**NHTSA Safety Recall 24V-662**

**SUBJECT: Campaign # 188 – Air Conditioner Soft Start Module**

# ICM Soft Start Replacement with Micro-Air Easy Start

# Truma Aventa/ICM Soft Start Replacement

Figure 12

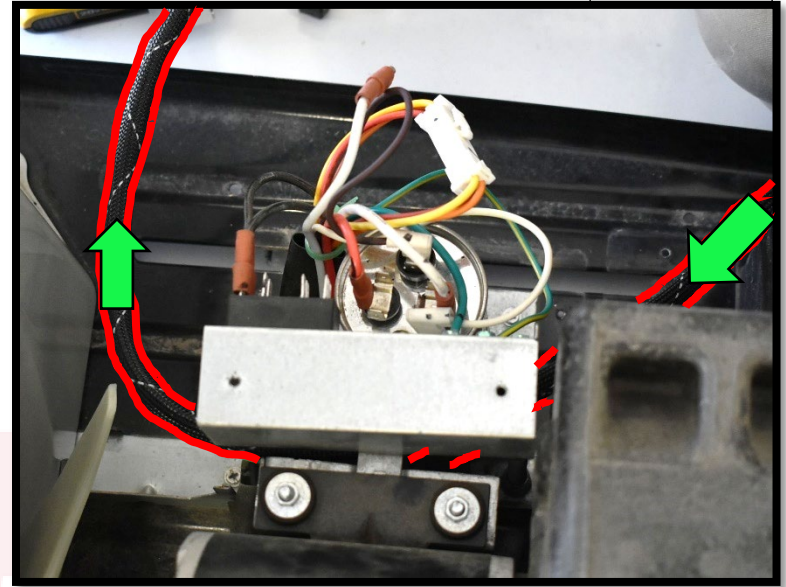
1. Feed the braided cord (wire ends) of the new Micro-Air Soft Start between the Capacitor Bracket and the Fan Motor Bracket. (See Figure 12)

Figure 13-A

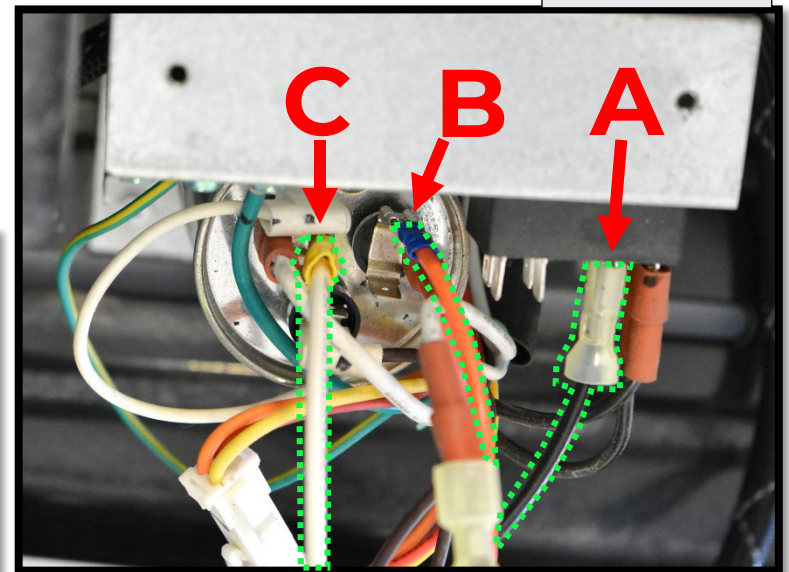
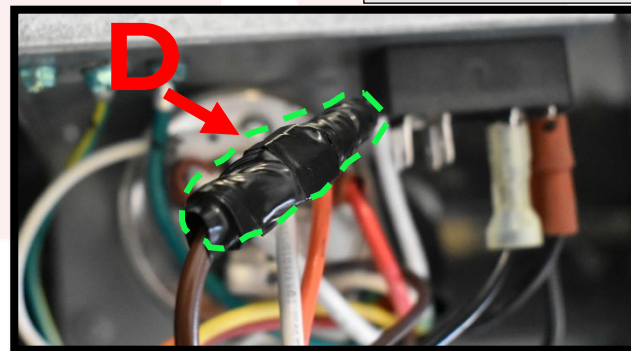
2. Install the new Micro-Air Soft Start's 4 Wires in their proper locations. (See Figures 13-A & 13-B)

A. The Black Wire of the new Soft Start needs to be connected to the right set of terminals on the terminal block. (A)

B. The Orange Wire of the new Soft Start needs to be connected on the right-side capacitor cap, where the ICM's Red wire was removed from. (B)

C. The White Wire of the new Soft Start needs to be connected to the left-side capacitor cap, where the ICM's White wire was removed from. (C)

D. The Brown Wire of the new Soft Start needs to

be connected to the connection point that has a White wire connected from that connection point, into the compressor. Use electrical tape to secure the connection point. (D)

Figure 9

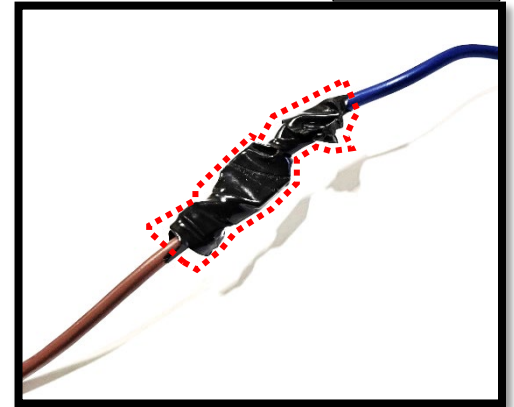
2. Locate the connection between the SoftStart Brown wire and the AC Blue wire. Disconnect this connection. (See Figure 9)
3. Locate the Yellow Y-Splice connection between the Red AC wire and the Black soft start wire. Cut out the Y-Splice from the Red connection leaving as much of the red wire as possible. (See Figure 10)

Figure 11

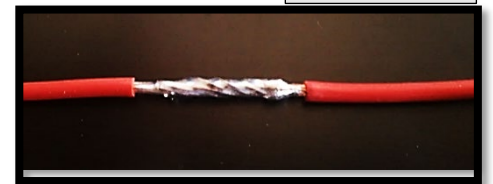
4. Reconnect the Red AC wire by solder splicing the two sides back together where it was previously spliced. (See Figure 11)
  - a. Before soldering, slide the Winnebago supplied black heat shrink over one side of the Red AC wire.

- b. After soldering, slide the Winnebago supplied heat shrink over the solder spliced connection to cover it fully. Using a heat source (lighter, heat gun, or similar) carefully heat the heat shrink sleeve over connection until it shrinks over the connection to create a tight protective cover.

- c. Tug on the soldered wire to confirm a strong soldered connection.

Figure 23

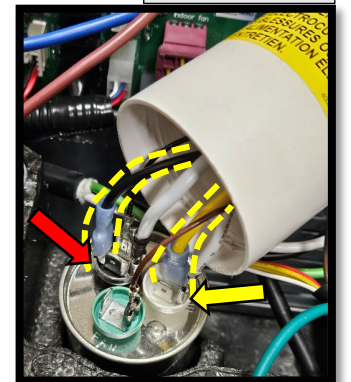
3. Carefully slide the Yellow wire from the SoftStart harness through the wire access hole in the white plastic capacitor cap and attach to the White terminal on the capacitor. (See Figure 23 – yellow arrow)

4. Carefully slide the Black wire from the SoftStart harness through the wire access hole in the white plastic capacitor cap and attach to the Black terminal on the capacitor. (See Figure 23 - red arrow)

# Reference Connections With Rework Complete

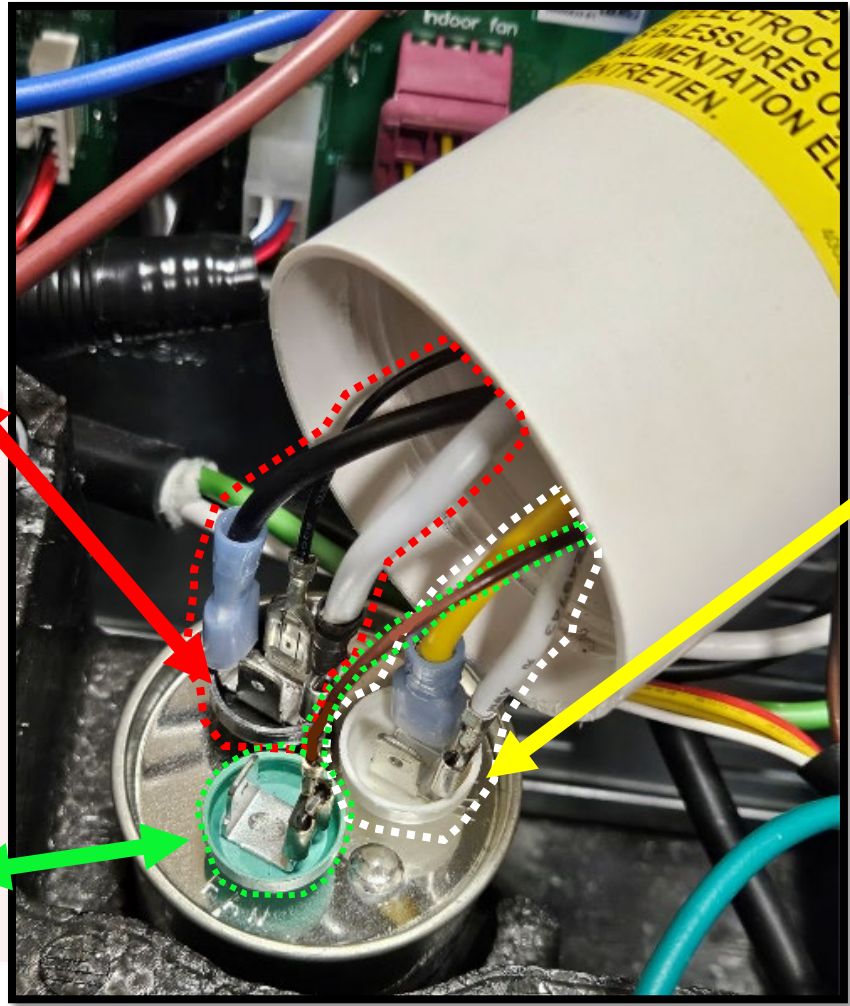
**Black** Capacitor Cap Connections:

- White AC Wire with Black Shrink
- Black AC Wire
- Black SoftStart Wire

**Green** Capacitor Cap Connections:

- Brown AC Wire

**White** Capacitor Cap Connections:

- White AC Wire
- Yellow SoftStart Wire
